Ginny Kidwell Amphitheater

Assessment October 23, 2018

ADA Checklist for Existing Facilities

Project: ADA Assessment Greeneville, TN

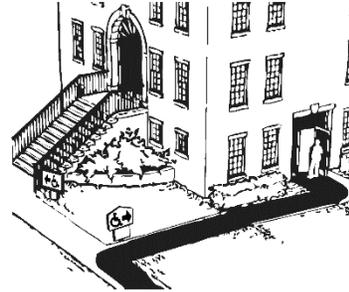
1.38 If the main entrance is not accessible, is there an alternative accessible entrance?

No

Can the alternative accessible entrance be used independently and during the same hours as the main entrance?

- Designate an entrance and make it accessible
- Ensure that accessible entrance can be used independently and during the same hours as the main entrance
-
